UNITED STATES PATENT AND TRADEMARK OFFICE

10/596,518

Erwin Hartmann

Office Action Summary	Application No. 10/596,518	Applicant(s) HARTMANN ET AL.	
	Examiner Vishal Patel	Art Unit 3676

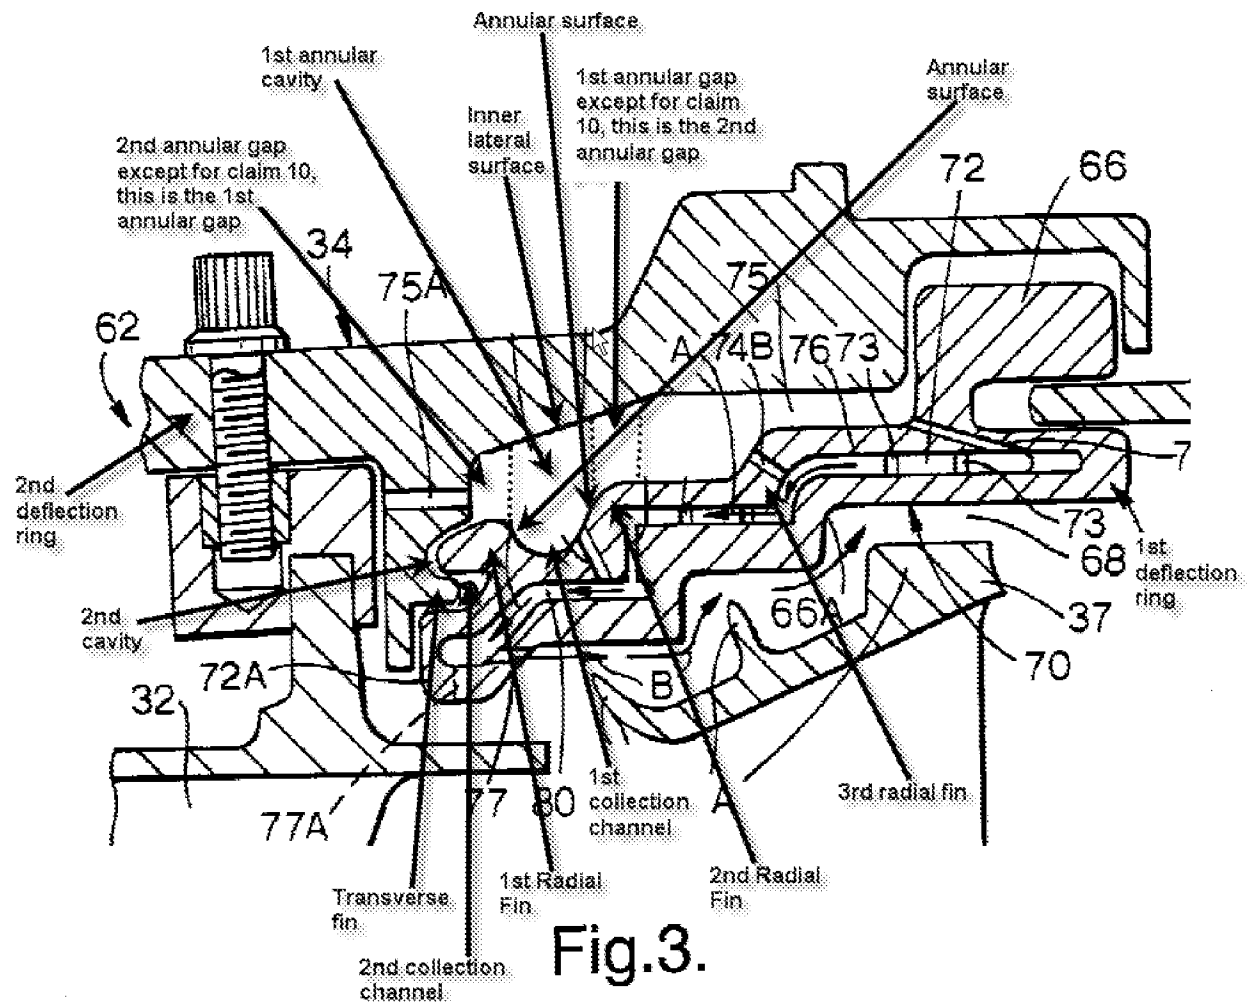
Lawer discloses a seal for an annular opening between members, the seal comprising: a first deflection ring concentrically arranged inside a second deflector ring and about a common axis of rotation; two radial fins formed on the first deflection ring, extending radial outward towards the second deflection ring without contacting the second deflection ring; a smooth, outwardly conical, inner lateral surface formed on the second deflection ring, radially opposing the two radial fins; a first collection channel delimited axially by the two radial fins and radially by the first deflection ring; a first annular cavity delimited axially by the two radial fins and delimited radially by the first collection channel and the inner lateral surface; and a second

collection channel delimited by a transverse fin extending axially from an inward radial limb of the second deflection ring, the inward radial limb axially inward of the first deflection ring, the second collection channel radially inward of the first collection channel and the two radial fins (see figure below).

Regarding claim 3: The first cavity has presents a radially innermost bottom whose radial distance to the second deflector ring is greater than the axial distance between the adjacent radial fins that bound the cavity (figure below).

Regarding claim 4: A first radial fin of the two radial fins is arranged further axially outward than a second of the two radial fins at the seal and at least partially closes off the seal with respect to an environment surrounding the seal in the axial direction is radially longer than the second radial fin (figure below).

Regarding claim 6: The first cavity is bound by annular surfaces that radially increase in distance from one another towards the second deflector ring (figure below).

Regarding claim 7: The annular surface is inclined at an angle with respect to the axis of rotation (figure below).

Regarding claim 8: The first cavity merges axially into a radial first annular gap between a first radial fin of the two radial fins and the second deflector ring and into a radial second annular gap between a second radial fin of the two radial fins and the second deflector ring (figure below).

Regarding claim 9: The first annular gap on an axially outer side of the first radial fin between the first deflector ring and the second deflector ring opens out freely into an environment axially surrounding the seal (figure below).

Regarding claim 10: The first annular gap is radially narrower than the second annular gap.

Regarding claim 11: The second annular gap runs radially closer to the axis of rotation than the first annular gap (figure below).

Regarding claim 13: The second annular gap opens out into a second cavity, the second cavity, which is annular in form, being at least partially enclosed by the first deflector ring and the second deflector ring (figure below).

Regarding claim 14: The second radial fin and a third radial fin, at the first deflector ring, lie freely axially opposite one another, separated from one another by the second cavity (figure below).

Lawer discloses the claimed invention except that the distance is a ratio of 1.4 times the axial distance and the angle is from 70° to 85°. Discovering an optimum range of a result effective variable involves only routine skill in the art. In re Kulling, 895 F.2d 1147, 14 USPQ 2d 1056. Without the showing of some unexpected result. Since applicant has not shown some unexpected result the inclusion of this limitation is considered to be a matter of choice in design. It would have been obvious to one having ordinary skill in the art at the time the invention was made to have the distance to be 1.4 times the axial distance and angle to be between 70° to 85° as a matter of design choice.
